ORIGINATION FORM

Proposed Revisions to a Standard Plans Index
(Please provide all information – Incomplete forms will be returned)

Index Number: **102-600**
Sheet Number (s): 9 of 12
Index Title: Pedestrian Control for Closure of Sidewalks

DROP-OFFS IN WORK ZONES

DROP-OFF CONDITION NOTES

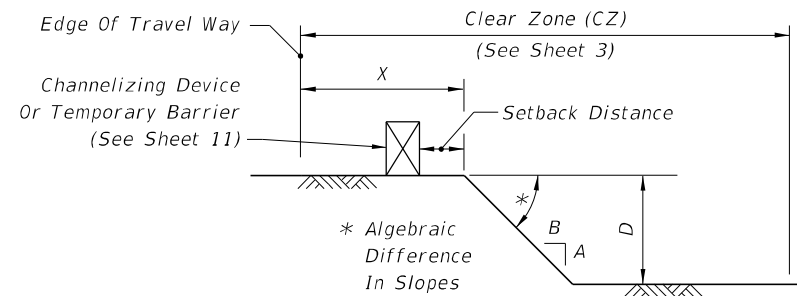
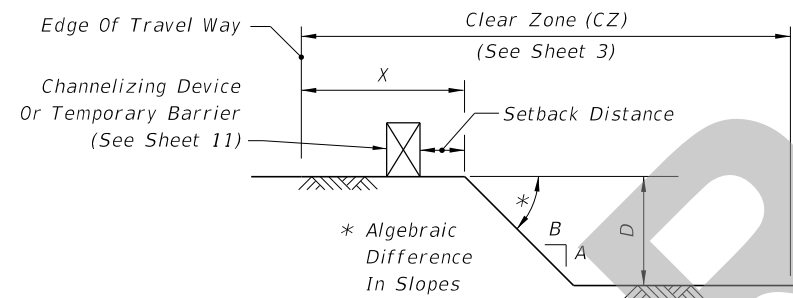
Sheet 9: Changed "Drop-off Conditions Notes" Note 5.

It was not intended that significant drop-offs be located immediately adjacent to the traveled way without shielding for substantial lengths. The proposed change corrects that oversight.

4. For Setback Distance, refer to the Index or Approved Products List (APL) drawing of the selected barrier.
5. For Conditions 1 and 3 provided in Table 1, any drop-off condition that is created and restored within the same work period will not be subject to the use of temporary barriers; however, channelizing devices will be required.

Changed

4. For Setback Distance, refer to the Index or Approved Products List (APL) drawing of the selected barrier.
5. For Conditions 1 and 3 provided in Table 1, an isolated drop-off condition less than 100 feet in length that is created and restored within the same work period will not be subject to the use of temporary barriers; however, channelizing devices will be required.
